DEVELOPMENT ASSESSMENT REPORT				
Application No.	MOD/2023/0170			
Address	18 Allen Street LEICHHARDT			
Proposal	Section 4.55(2) Modification to DA/2022/0737, to include addition of a first floor studio above the approved detached storage area and decrease first floor setback to original dwelling house.			
Date of Lodgement	20 June 2023			
Applicant	Ms Jodie Dang			
Owner	Mrs Sophie C Ellis Mr Charles T Garcia			
Number of Submissions	One (1) in opposition			
Value of works	\$854,700.00			
Reason for determination at Planning Panel	Section 4.55(2) Modification Application that results in a variation of the Landscaped Area development standard of greater than 10%			
Main Issues	<ul style="list-style-type: none"> • The development is not substantially the same development to that which was originally granted • Non-compliance with the development standard under Section 4.3C (Landscaped Area) of <i>Inner West Local Environmental Plan 2022 (IWLEP 2022)</i> • Inadequate front setback of first floor addition to the dwelling house • Bulk and scale impacts from the proposed two storey studio at the rear • Overshadowing impacts and lack of demonstrated compliance with applicable solar acces

C1.0 General Provisions

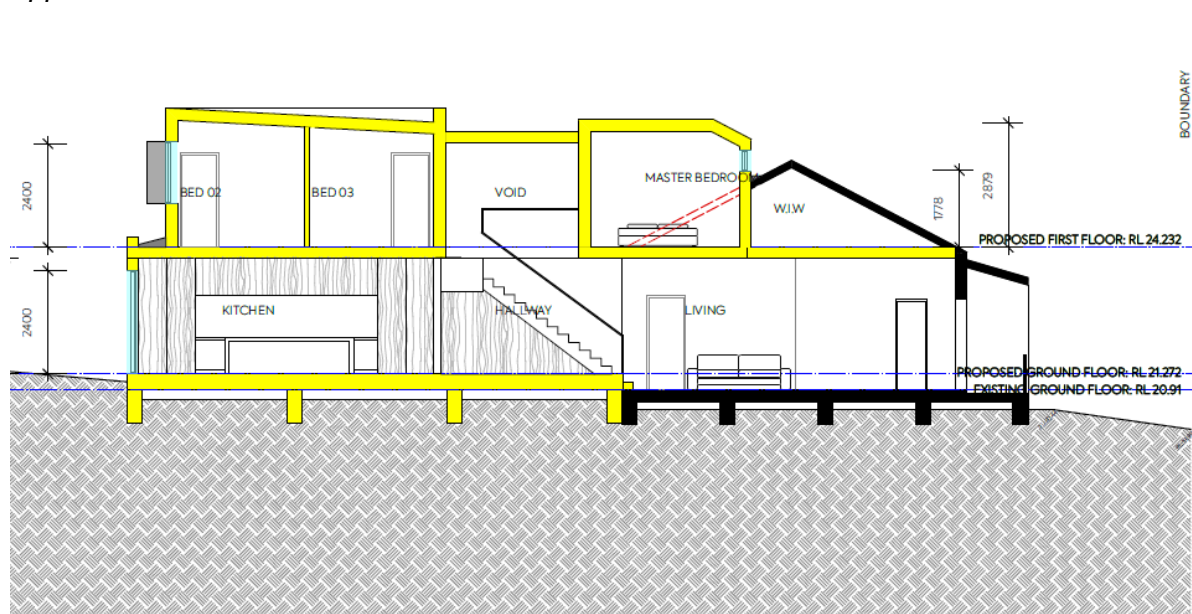
For reasons discussed in this report, concern is raised that the proposed modifications to the first floor addition to the main dwelling is of a form and appearance that will not be compatible with the existing dwelling house or its context and that does not meet desired future character controls for the West Leichhardt Distinctive Neighbourhood, and has not demonstrated compliance with the following Objective of Part C1.0 of the LDGP2013:

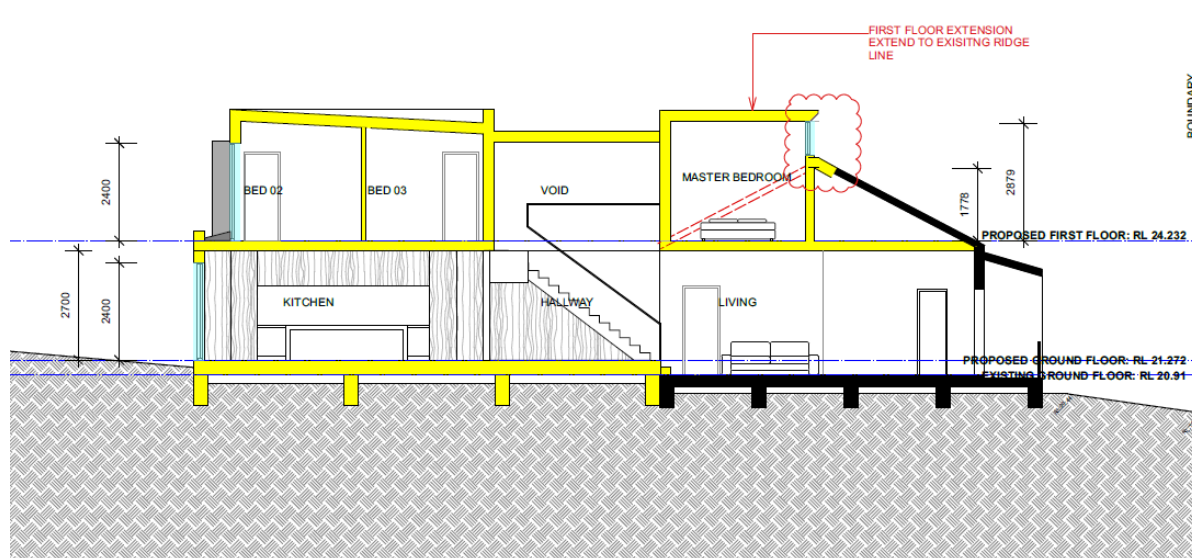
The current modification proposes to locate the proposed first floor master bedroom to commence at the location of the original roof ridge, which will be clearly visible from the street, and result in a roof form that clearly disrupts aesthetics of the original roof form and create an undesirable roof form to the street (see extract of the proposed section below):

It is also noted that the proposed northern elevation under the current application does not appear to accurately depict the amount/form of the glazing depicted on the proposed sections. Notwithstanding this, the proposed modifications to the first floor addition are considered to be of a form that is disruptive to the existing roof form and the proposed modification is clearly contrary to Control C14 of this part which outlines that any first floor and above additions, where attached to the existing roof forms, shall be subordinate to that roof form and must be set 300mm below the ridgeline (reproduced below):
